Revisions and Errata List

AISC Steel Design Guide 24, 1st Printing (Printed Edition) and March 2015 Revision (Digital Edition)

February 16, 2023

The following list represents corrections to the first printing and the March 2015 revision (digital edition) of AISC Design Guide 24, *Hollow Structural Section Connections*.

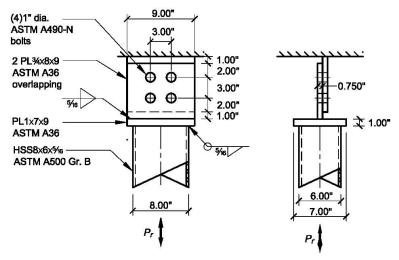
Figure 5-9 should be revised so that the connection plate dimensions are as shown in the figure below:
